# Special Bulletin **SB-10060329-9191** **SP15-23**

## STEER LEVER BOLT INSPECTION

Prevost vehicles

Figure 2

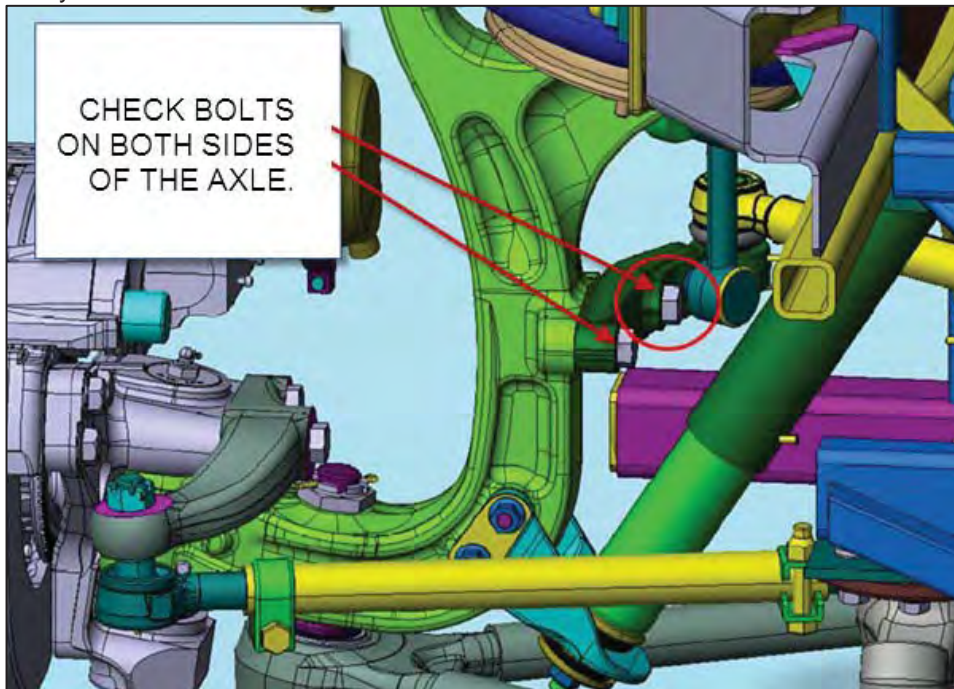
On the front independent suspension, inspect the bolts highlighted in fig. 2. Note that you may have to remove the shocks and the sway bar links to perform the replacement. Support the body on both sides before removing any components.

- 1) Verify the bolt head for the marking "OF". If present on one of the bolts, replace BOTH bolts

- 2) Verify **both sides** of vehicle

- 3) Replace one bolt at a time
  - Short Bolt M20 X 60 G12.9                      PN 611305 QTY 2/VEH
  - Long Bolt M20 X 80 G12.9                      PN 611307 QTY 2/VEH
- 4) Run a **M20 X 2.5 size tap** in the threaded section of the axle. You have to go from the back side and not the bracket side
- 5) Clean the bolt thread as well as the support thread using degreaser. Dry with compressed air.
- 6) Apply 271 Loctite or Permatex 27100 on bolt and threaded hole
- 7) Torque to **547 FT LBS**, Qty: 2 per side
- 8) Apply undercoating on Bolt heads
- 9) Reinstall sway bar links. Torque to **165 lbf-ft.**
- 10) Reinstall shocks. Torque to **110 lbf-ft.**
- 11) If no **“OF”** marking on the bolts, the vehicle is Conform.
